EXPERT REPORT

Opinion re “Expert Report of Mark Jacobson, Ph.D.” April 6, 2018

Kelsey Cascadia Rose Juliana, et al. v. United States of America, et al.

Howard J. Herzog
Senior Research Engineer
Massachusetts Institute of Technology
MIT Energy Initiative
77 Massachusetts Avenue
Cambridge, MA 02139

Figure 2. Six-year time series comparison of energy storage changes used to align electricity demand with electricity supply per Jacobson et al. (2015b)

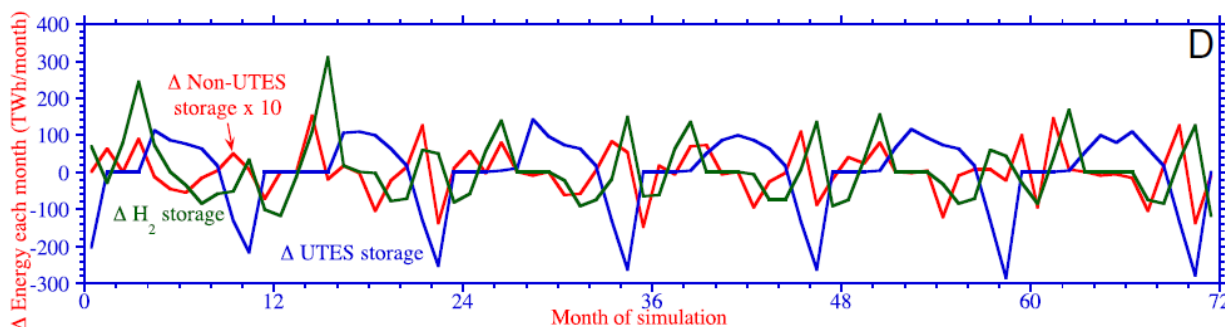
Jacobson et al. (2015b) documents that LOADMATCH uses several energy storage technologies to align electricity demand with electricity supply. As shown in Figure 2, (reproduced from Jacobson et al., 2015b (page 15062), Jacobson et al. (2015b) rely primarily on hydrogen storage and underground thermal energy storage (UTES) as their storage mechanisms to ensure sufficient supplies of electricity exist to meet demand for electricity at all times. Therefore, I focus my assessment on these two technologies. I summarize my analysis of these systems below, with additional detail provided in Appendices C and D for hydrogen storage and UTES, respectively.

My analysis indicates that Jacobson underestimates costs for the hydrogen storage system by at least a factor of ten, as I detail in Appendix C. In my view, there are three main reasons for his underestimation:

Figure 3. Photo of the Drake Landing Solar Community

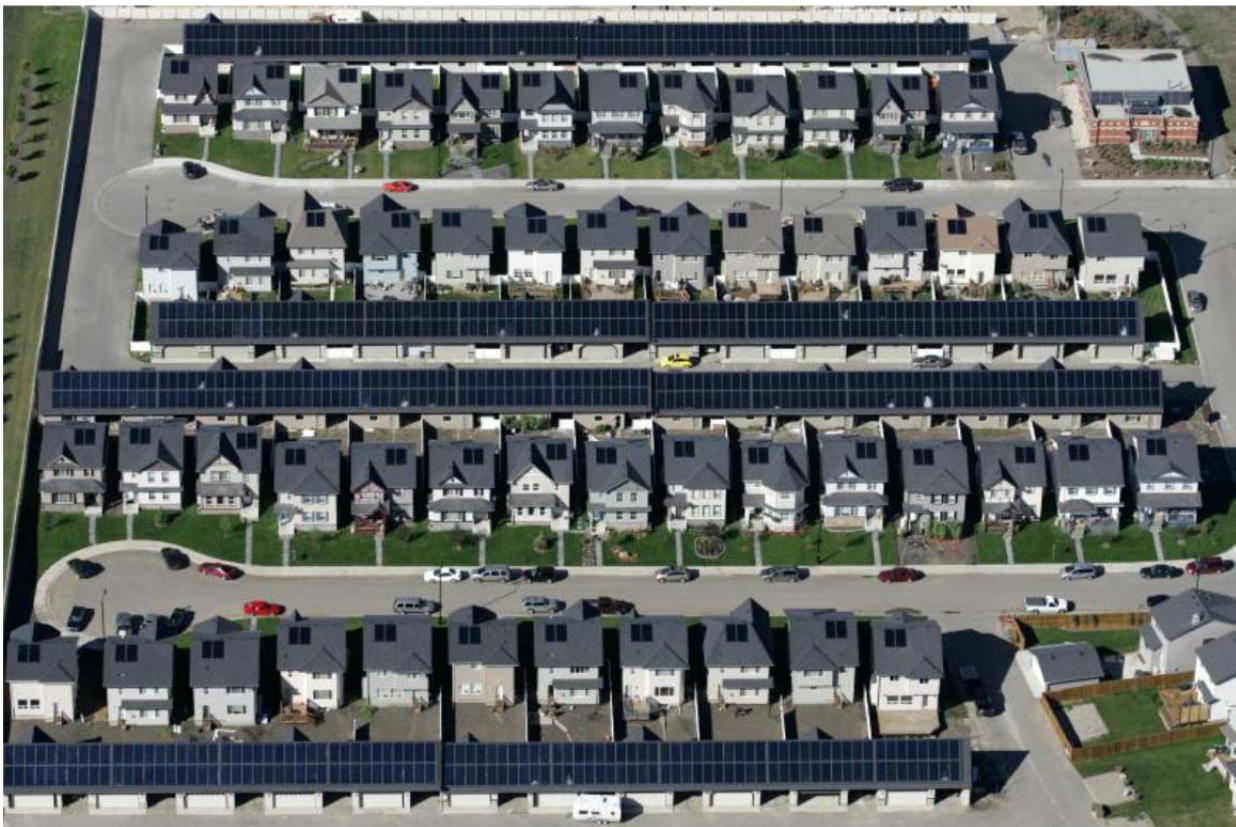
Jacobson's basis for UTES deployment and functionality is the Drake Landing Solar Community (DLSC), a planned community of 52 homes in Canada.

Based on this concept, Jacobson assumes that 85% to 95% of all air and water heating in the United States will be realized from energy stored in UTES.¹⁵ Achieving this objective requires UTES systems to be retrofitted to tens of millions of homes in the United States. For reference, a picture of DLSC is included below as Figure 3. The picture shows the large area required for solar thermal panels. It also shows a lack of trees in the community, as this would block sunlight. For efficiency, homes in DLSC are spaced closely together. Not pictured, but present, are the 144 boreholes in the community that give access to the underground storage reservoir.

Jacobson offers insufficient justification or analysis to support his claim that 85% to 95% of all air and water heating in the United States can be realized from energy stored in UTES. Neither in his Expert Report, nor in his articles underpinning his Expert Report, does Jacobson address questions as to whether DLSC can be replicated on a large scale within the United States. Specifically, Jacobson provides no response to:

Figure 4. Net Daily Coefficient of Performance (COP)

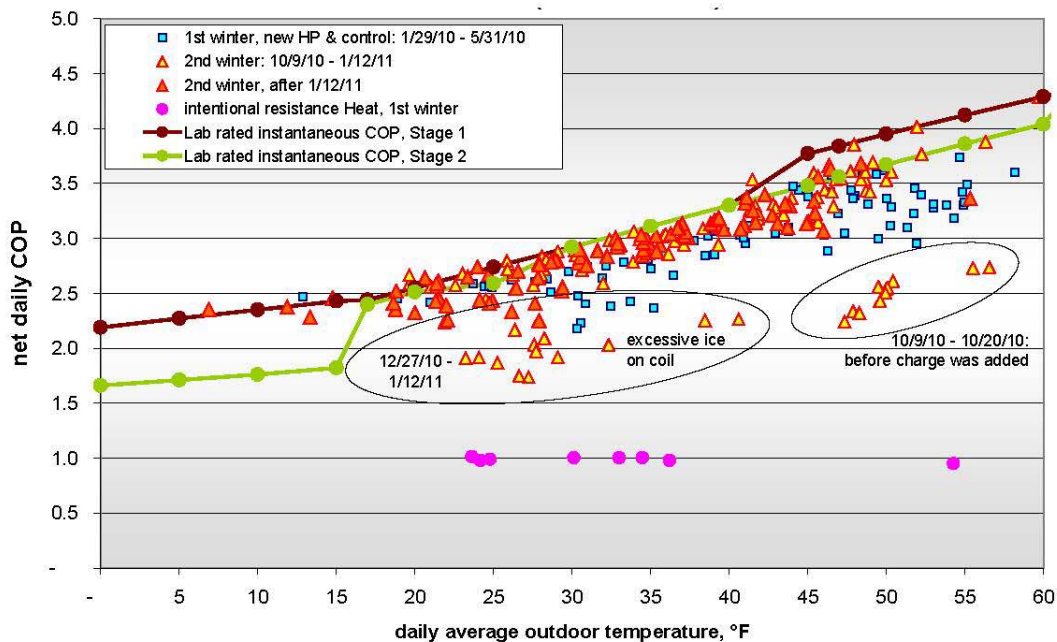
for each month in his model. In my view, the use of these historically average temperatures does not capture extreme weather events, because, among other reasons, smoothing these temperatures over a month's time horizon eliminates the spikes in temperatures, and the associated spikes in energy demand.

An example of extreme weather conditions is bitter cold over much of the US for an extended period of time, as occurred during the polar vortex (January 2014) or the cold snap last winter (December, 2017- January 2018). Temperatures were well below average by 10 degrees, 20 degrees, or even more in some places.²⁵ The obvious direct effect of lower temperatures is the demand for more heating, as well as strain on the performance of energy systems. For example, the efficiency of heat pumps (see Figure 4 below) is measured by the coefficient of performance (COP), which declines substantially in the cold. At 0°F, a heat pump requires about twice the electricity per unit of heat delivered as that required at 40°F. At subzero temperatures, which were present during these cold snaps, the efficiency degrades even more.

Figure C-1.

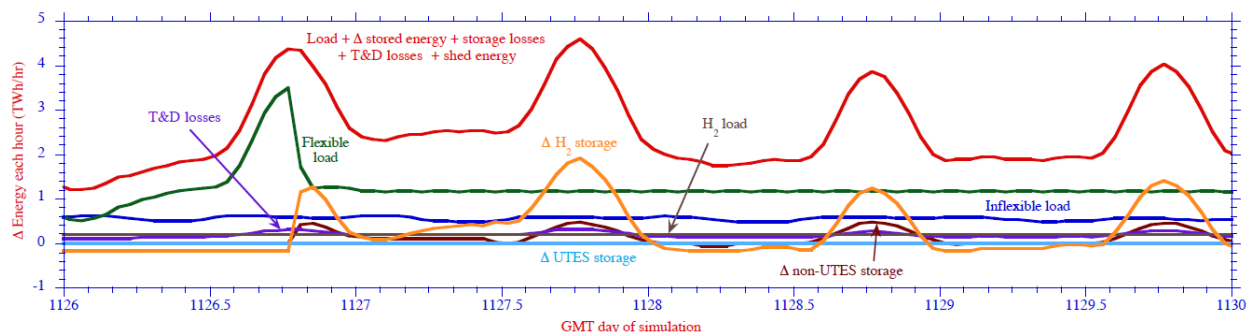
However, this is in contradiction to the figures presented in Jacobson et al. (2015b). Specifically, the third panel of Figure S6 on page 19 of the Supporting Information to Jacobson et al. (2015b) is reproduced below as Figure C-1.

In this figure, the electrical load going to the hydrogen storage system is represented by the orange line. The load going to the hydrogen storage system is shown to be about 2 terawatt-hours per hour (TWh/hr), or 2,000 gigawatts (GW). In Jacobson et al. (2015b), page 15061, Table 1, the average load for the system is listed as 180.2 GW.⁴⁴
